Environmental Protection Agency

Environmental Impact Statement Comments

Oyster Creek Nuclear Generating Station

Figure 1

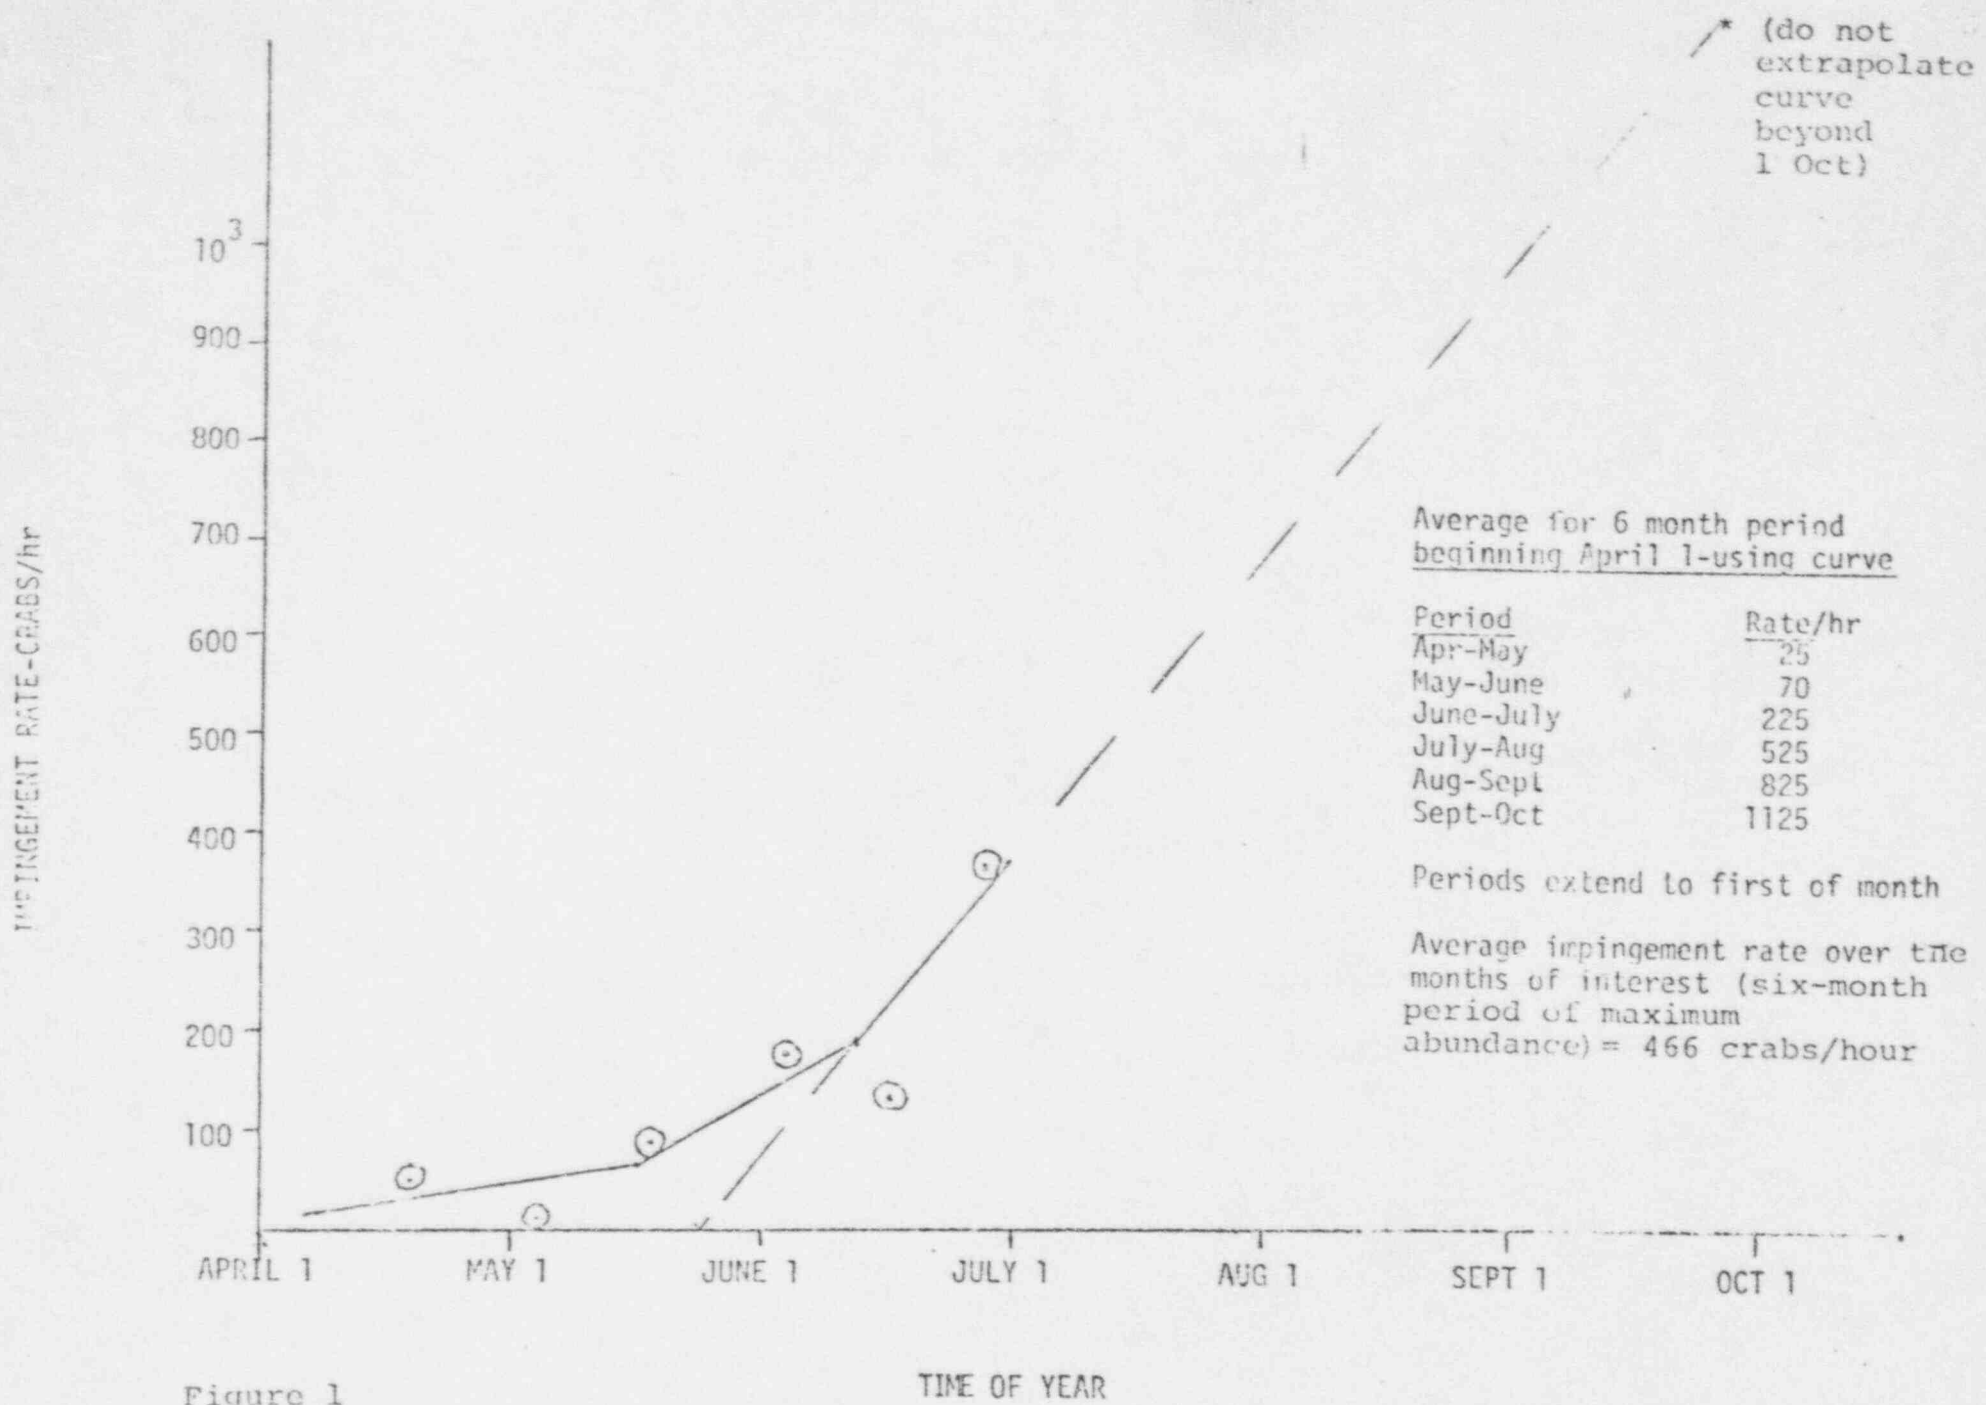
We feel that the average impingement rate factor is much too low as it does not consider time of maximum abundance. Using the attached figure prepared by EPA's Region II, which is an extrapolation of the applicant's data, and projecting the impingement rates for the six months of maximum abundance, we arrive at an impingement rate for the period April-October, of 466 crabs/hour.

that the impingement experience will cause no further harm to live crabs dumped with other screen washings into the discharge canal. In our opinion, this assumption is unfounded; we would propose a figure more on the order of 0.50 for a total mortality rate. This figure considers such factors as mechanical shock and dumpage into a canal in which temperatures have been measured at 104°F.

Having re-estimated the applicant's factors, and calculating, $(4.66 \times 10^2 \text{ crabs/hr}) \times (4.38 \times 10^3 \text{ hr}) \times (0.50) = 1.02 \times 10^6$ crabs lost.
